FCC Class II Permissive Change Request Letter

RE: FCC Permissive II Change Request for Company: Arovast Corporation FCC ID: 2ARBY-CORE-200SA

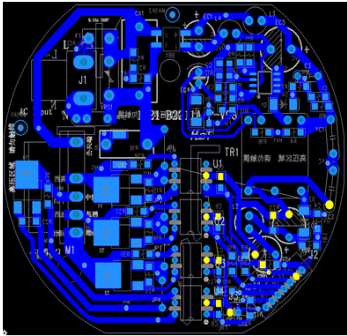
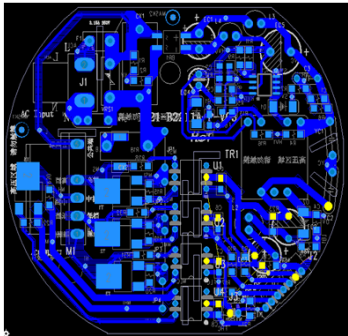
Based on the original product to change power board Layout, The RF module has not changed.

SN	Name	Change Description		Note
		Before	After	
1	PCB Layout			
2	PCB slotting	 	 	
		1、CY1, CY2 slotting 2、Optocoupler location slotting:1.3mm	1、CY1, CY2 slotting removing 2、Optocoupler location slotting:1.6mm	
3	PCB circuitry			
		The secondary output lines are at the 7th and 9th pins of the transformer.	The secondary output lines are at terminals 6 and 10 of the transformer.	
4	Transformer	 1. 规格 3.75.9 寸 2. 磁芯包胶带20 3. 标签在产品+5000, VE 10 P20 1; 数量生产时标签使用透明或黑色字或喷码或激光打标; TTP4; 表示年份周期 4. 次级磁芯背胶二层	 底视图	Change of supplier
5	R13 Resistor	/	/	
		15K/0805/F	14. 3K/0805/F
